Department of Energy

September 27, 2012

Waste Treatment and Immobilization Project Response to the Defense Nuclear Facilities Safety DNFSB Concerns: Electrical Distribution System

Example of Single-line for UPS power to large motors with Active Filter Connected.

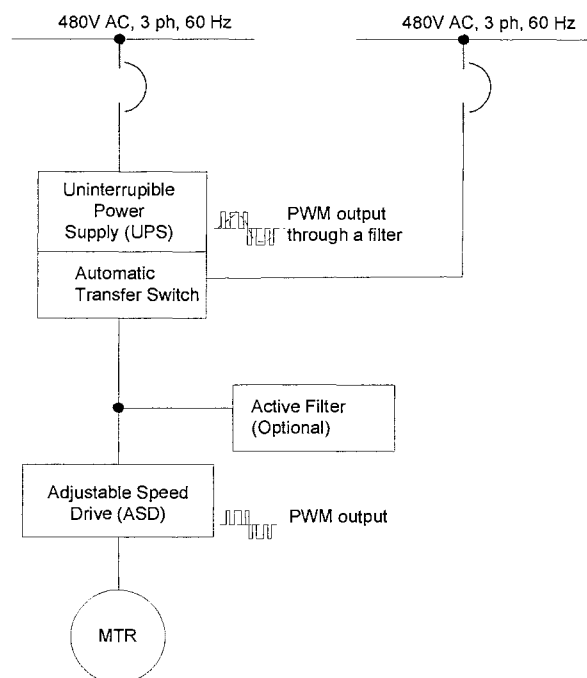
- c) DNFSB Key Point: The WTP project will need to determine the potential voltage fluctuations and harmonics inflicted on ASDs due to switching to and operating on power from UPS systems, and the effects on the ASDs and the driven motor's performance. The project team will have to evaluate the potential for these phenomena to impact system reliability, and develop and implement requirements for filtering equipment for each UPS, ASD, and motor combination that performs a SS or SC function.

- d) DNFSB Key Point: In these circumstances, the solutions required to address the problem were often expensive, labor intensive, and proprietary.

For any busses that are found as a result of the harmonic analysis to have potentially harmful levels of harmonics, typical cost-effective solutions to be taken by the project include one or more of the following:

- Confirm that the connected equipment is immune to the calculated harmonics
- Relocate loads to other busses
- Install line reactors in circuits upstream and/or downstream from ASD/Motor
- Install passive filters in ASDs (trap harmonics to ground)
- Install active filter which generate opposing (canceling) harmonic waveforms

The above process of design, harmonic analysis, and mitigation (if necessary) of harmful levels of harmonics is a normal design process for a large industrial facility like WTP. If problem areas are identified, the above are typical cost-effective solutions for any busses with harmful levels of harmonics.

The illustration shows the application of an active filter to offset harmful harmonics, if they were to occur between the UPS and ASD of a motor circuit.

Follow-up Action: The project is already scheduled to develop Harmonic Analyses using ETAP Software to locate any buses which exceed the acceptability criteria defined in IEEE 519. Any buses with excessive harmonics will be evaluated and determined if equipment should be added to reduce harmonics to an acceptable level.

Typical Residual Voltage Decay of Induction Motors 200-300 HP

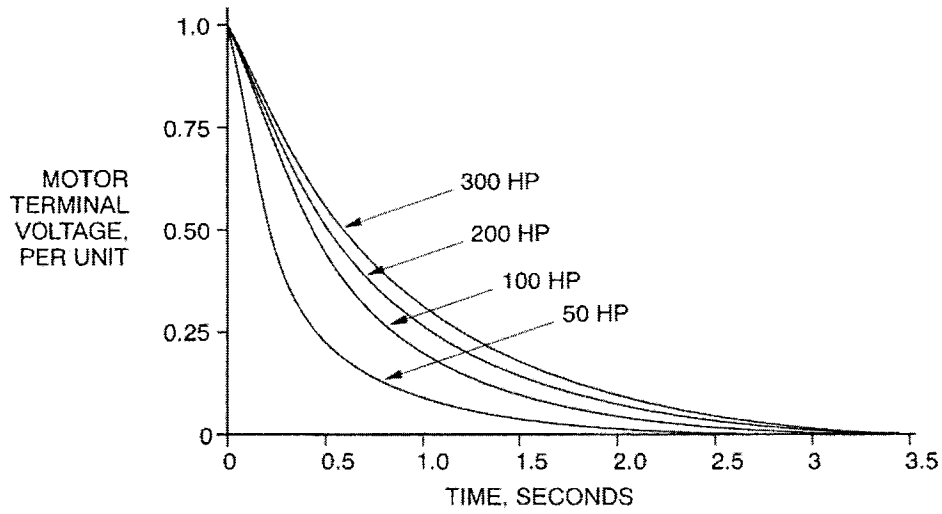
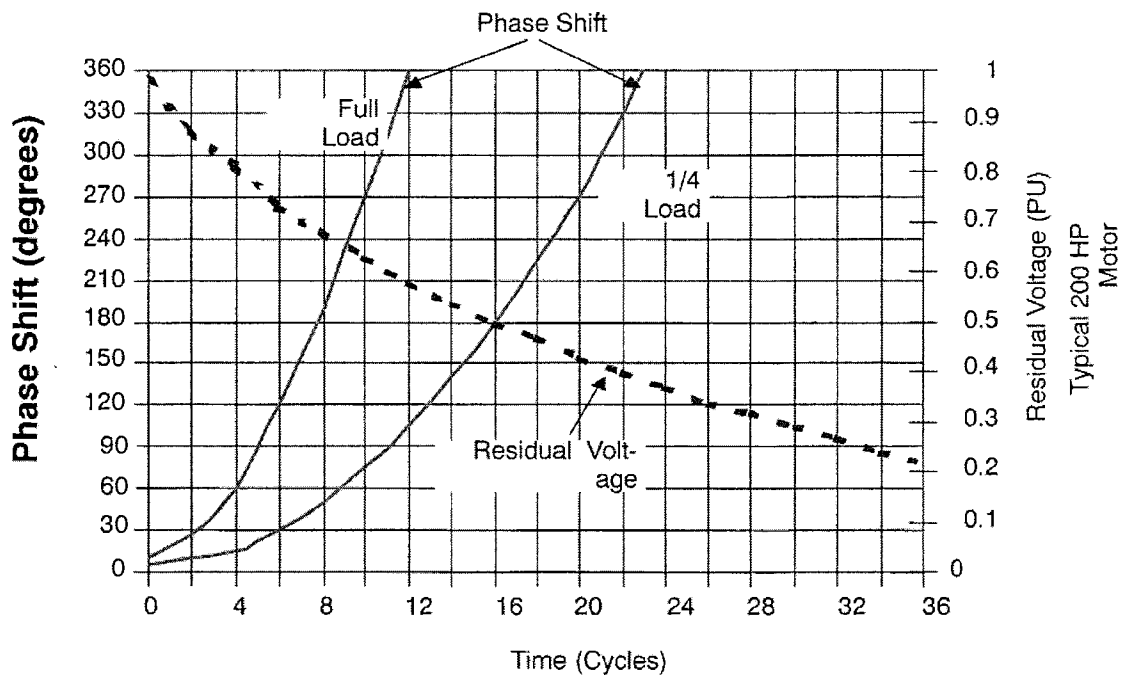
- a) DNFSB Key Point: When the motors are exposed to an automatic bus transfer or fast reclosing of the power supply breaker, there is a potential for the incoming voltage to be out of phase with that induced in the rotating machine. This can result in the development of a transient current and torque, the magnitude of which may range from 2 to 20 times the value rated for the machine, potentially causing damage to the motor.

Safe (slow) transfers or re-closings can be accomplished by a time delay equal to or greater than 1.5 times the open-circuit alternating-current time constant of the motor (NEMA MG-1-20.33.1).

This is equivalent to the residual voltage of the coasting motor decaying to approximately 25 percent of normal system voltage. A typical 200 hp motor decays to 25 percent of normal system voltage in approximately 0.5 seconds. Therefore, a time delay of 0.5 to 1.5 seconds over the range of 25 to 200 hp would be sufficient. Motors larger than 200 hp require slightly longer delays. Generally even the largest motor under load has its residual voltage decay to 25 percent within 5 seconds of loss of power.

The Figures on the next page, from two different sources, show that the residual voltage for both (typical) 300 hp and 200 hp motors will decay to 0.25 per unit (volts) in less than 1.5 seconds. Therefore, the 5 seconds listed above is a conservative number. However, the time for residual voltage to decay during fast transfers is not relevant to WTP since non-ASD connected motors will shutdown on loss of power and require manual restart. ASD connected motors, with automatic restart, are designed to catch the (spinning) motors on the fly.

Fast Transfers are not a problem on WTP because the only motors with automatic restart after a loss of power are connected to Adjustable Speed Drives programmed to synchronize to a spinning motor.
